REG. REF. NO. 91A 1661

Proposed: Dwellhouse and septic tank A.I.

At: Miltam Rd, Kilakee North Parkland

Development : Dwellinghouse and septic tank.

DRG. NO. 910028 - 13

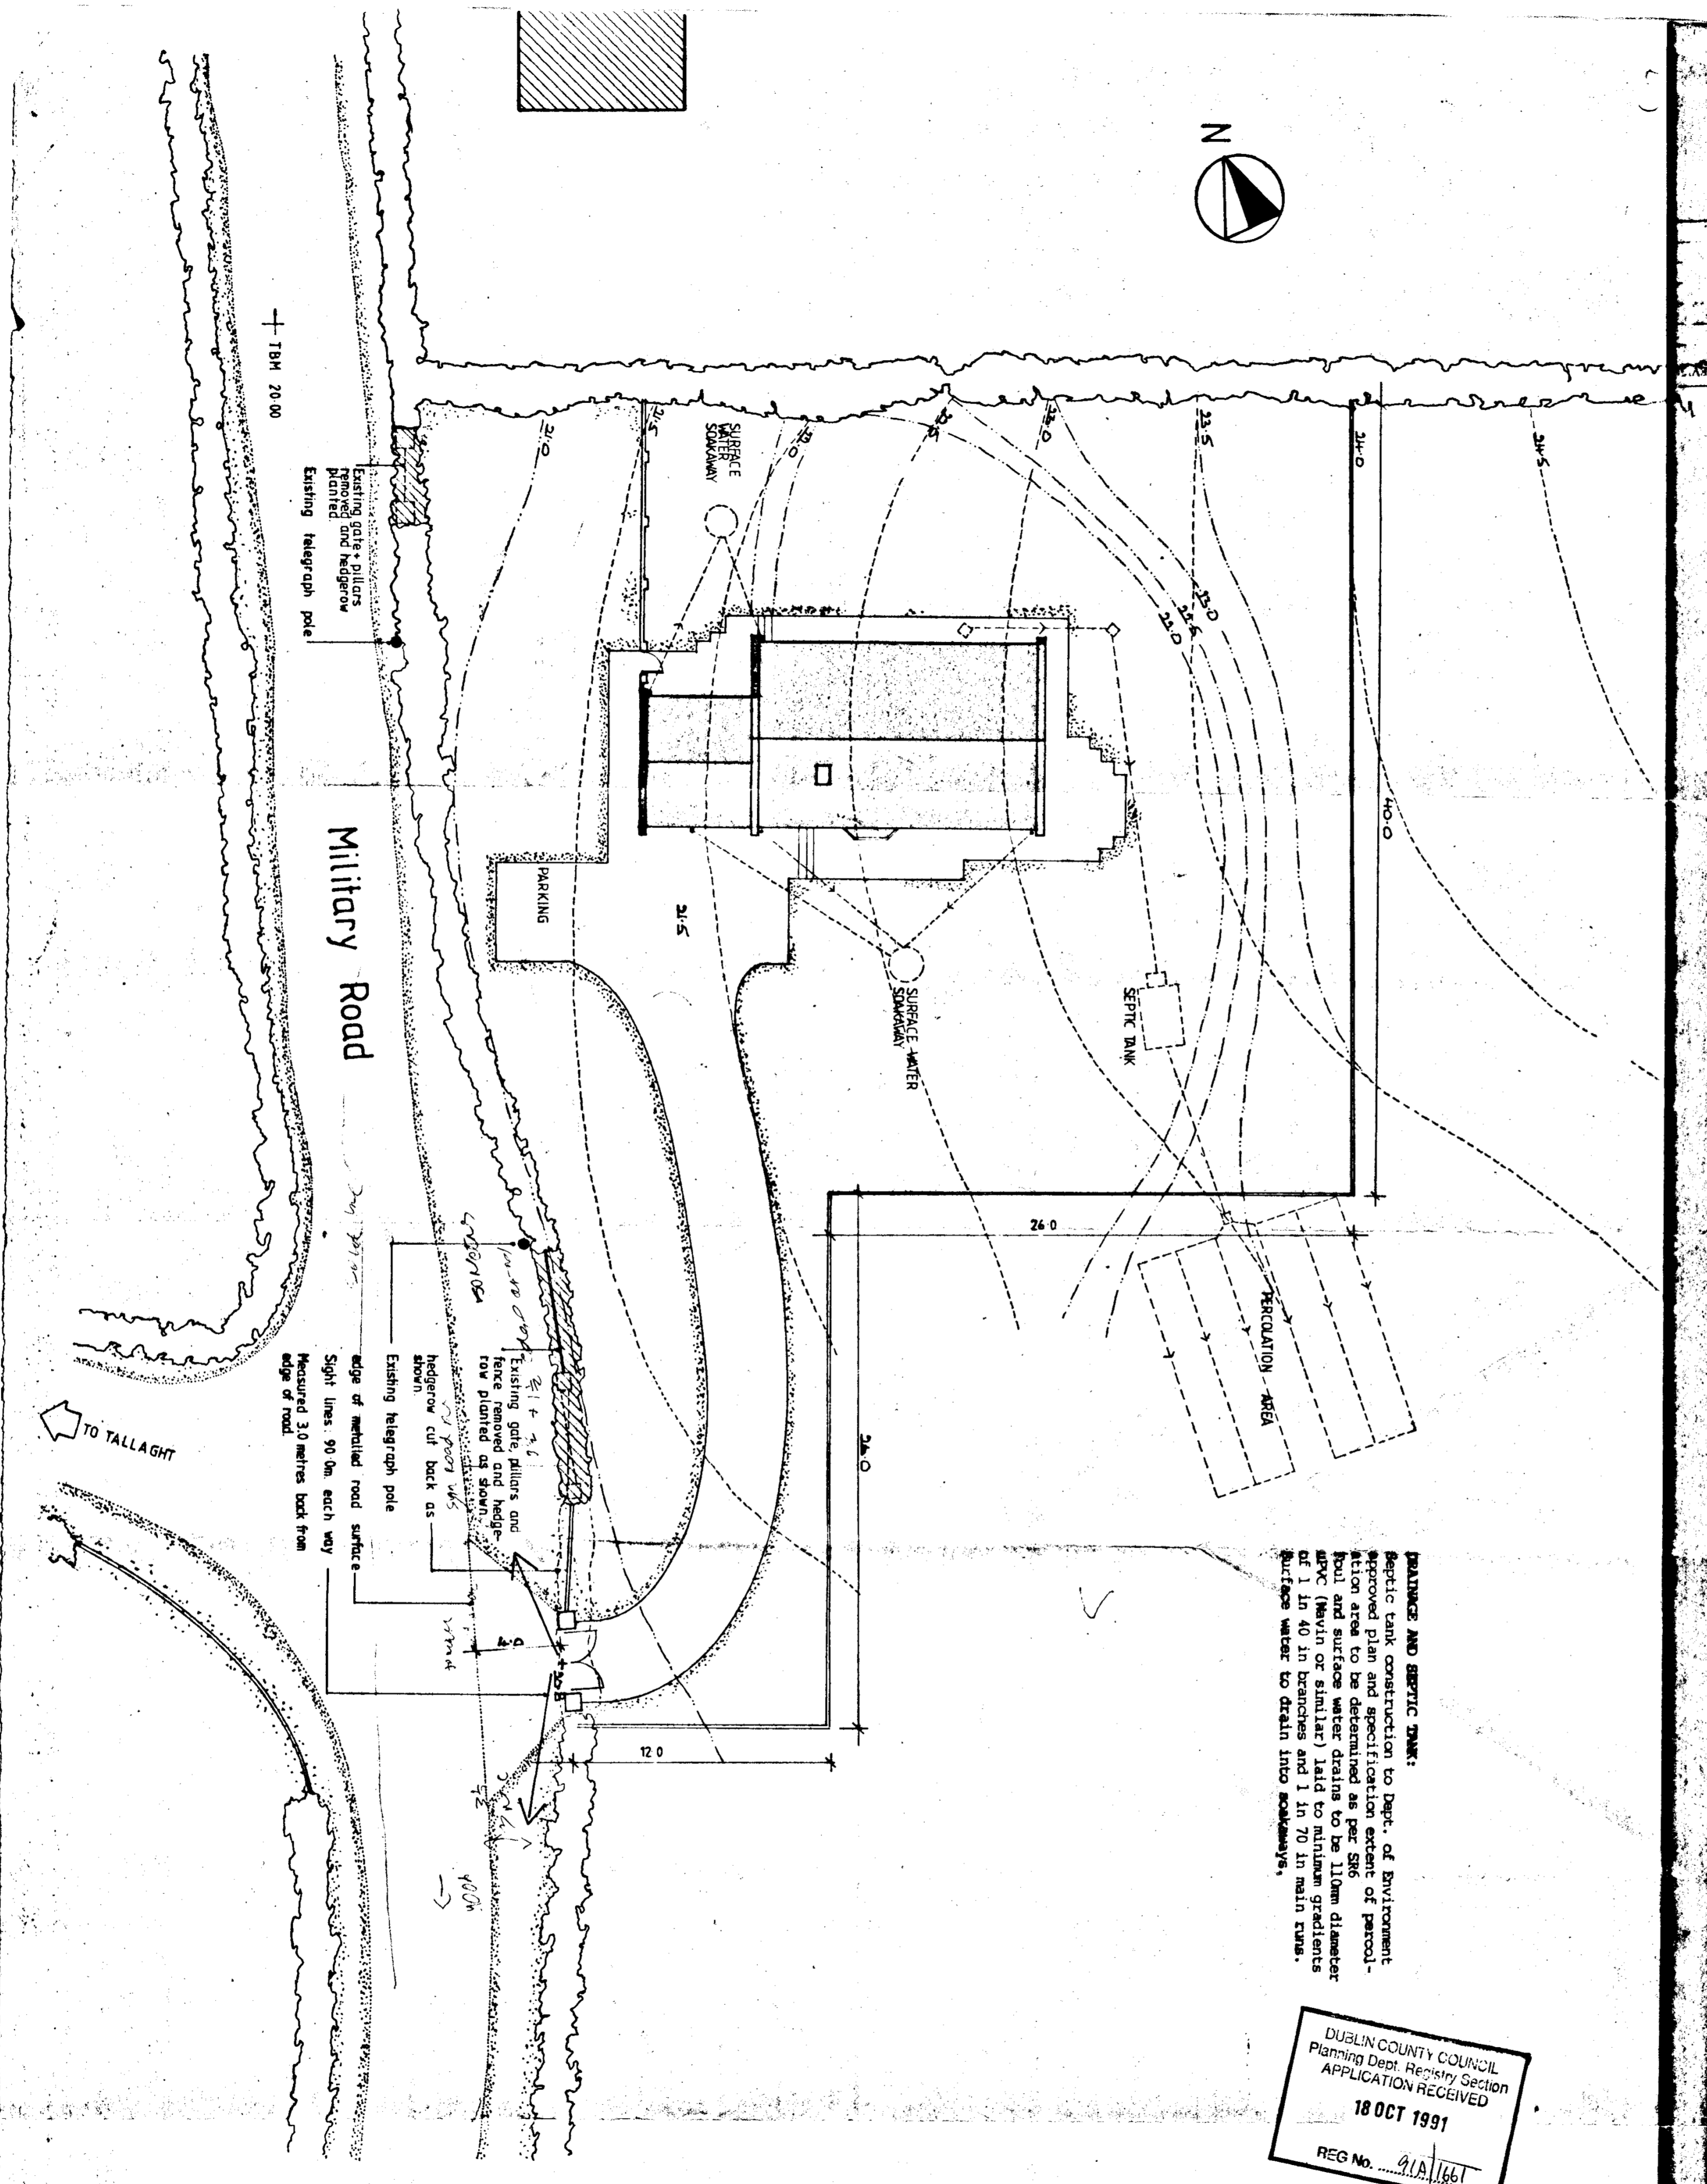
04 It is noted that the proposed percolation area is located outside the site boundaries. The applicant is requested to revise the site boundaries to include percolation and reserve percolation areas, and to submit drawings showing this.

PERCOLATION AND SEPTIC TANK:
 Septic tank construction to Dept. of Environment approved plan and specification extent of percolation area to be determined as per S86. Soil and surface water drains to be 110mm diameter PVC (Hevin or similar) laid to minimum gradients of 1 in 40 in trenches and 1 in 70 in main runs. Surfaces water to drain into soakaways.
